N9914A-02 <u>S E R V I C E N O T E</u>

N9914A FieldFox Handheld Analyzer

FieldFox instruments with the serial numbers listed on the following page may generate potential DANL failure due to different inductor being placed. A new RF board is required if DANL improvement is necessary.

Figure 1: Image showing the good and bad inductor on location U678 at RF Board

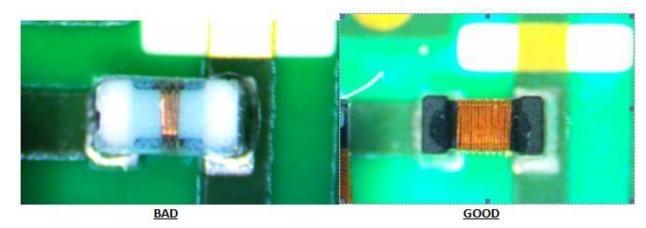
FieldFox instruments with the serial numbers listed below may show potential DANL failures with 3-4 dB difference due to misloaded inductor on the RF board. If DANL improvement is necessary, a new RF board is available to fix this it.

Affected FieldFox with necessary DANL improvement are required to send back to Agilent factory for a new RF board replacement. Test and Adjustment shall be done before shipping back to customer.
